10/697,180

United States Patent and Trademark Office

Á
	Application No.	Applicant(s)
Office Action Summary	10/697,180	MINAMIO ET AL.
	Examiner	Art Unit
	Long K. Tran	2818
The MAILING DATE of this communication appeariod for Reply	pears on the cover sheet w	ith the correspondence address
A SHORTENED STATUTORY PERIOD FOR REPL THE MAILING DATE OF THIS COMMUNICATION. - Extensions of time may be available under the provisions of 37 CFR 1. after SIX (6) MONTHS from the mailing date of this communication. - If the period for reply specified above is less than thirty (30) days, a rep - If NO period for reply is specified above, the maximum statutory period - Failure to reply within the set or extended period for reply will, by statut Any reply received by the Office later than three months after the mailin earned patent term adjustment. See 37 CFR 1.704(b).	136(a). In no event, however, may a by within the statutory minimum of thir will apply and will expire SIX (6) MON e, cause the application to become Al	reply be timely filed ty (30) days will be considered timely. NTHS from the mailing date of this communication. BANDONED (35 U.S.C. § 133).

DETAILED ACTION

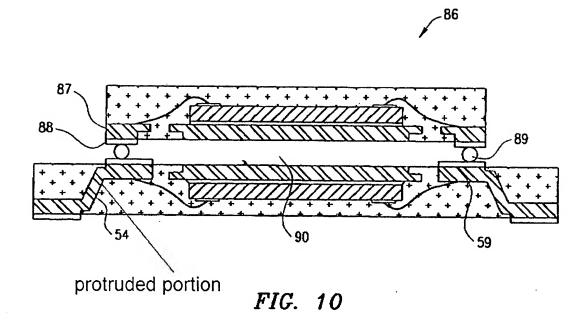
Regarding claim 1, Crowley discloses a lead frame 62 (figs. 2, 3 & 10), comprising:

a frame (figs. 3, 6 & 8); and

a plurality of inner leads 54, 75, 77, 83, 87 (figs. 2 – 14), extending inward from the frame, wherein the inner lead 54, 75, 77, 83, 87 includes a protruded portion provided on a surface of its outer portion, the protruded portion protrudes in a thickness direction, and a step portion is formed in a side portion of the protruded portion.

Regarding claim 2, Crowley discloses the step portion is formed as a portion with two steps (figs. 4 - 14).

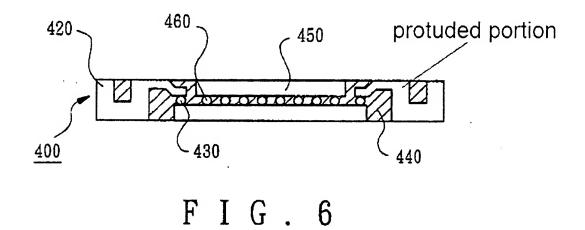
Regarding claim **4**, Chun-Jen discloses a resin-encapsulated semiconductor devices 100/200/300/400 (fig. 5), comprising:

a semiconductor chip 110/210/310/410 (figs. 1-6) having a group of electrodes (not labeled);

a plurality of inner leads 120/220/320/420 (figs. 1 – 6) that are arranged along a periphery of the semiconductor chip and are connected to the group of electrodes of the semiconductor chip, respectively; and

an encapsulating resin 140/240/340/440 (figs. 1-6; column 2, lines 61-62) that encapsulates a connection part located between the semiconductor chip and the inner leads 120/220/320/420, with a part of each of the inner leads being exposed from the

encapsulating resin to form an external terminal (upper surface and lower surface of the inner leads),

wherein the inner lead 120/220/320/420 includes a protruded portion provided on a surface thereof on an outer side relative to the periphery of the semiconductor chip 110/210/310/410, the protruded portion protruding in a thickness direction with a step portion formed in a side portion of the protruded portion,

the group of electrodes of the semiconductor chip is connected to surfaces of inner portions 122/322/422 (figs. 2,3,5 & 6; 422 not labeled; column 4, lines 18-19) of the inner leads 120/320/420 located on an inner side relative to their protruded portions, through electroconductive bumps 130/330/430 (figs. 1,3 5 & 6; column 4, lines 16-19), respectively, and

the encapsulating resin 140/340/440 encapsulates the semiconductor chip 110//310/410 and the electroconductive bumps 130/330/430 and is formed to expose surfaces of the protruded portions.
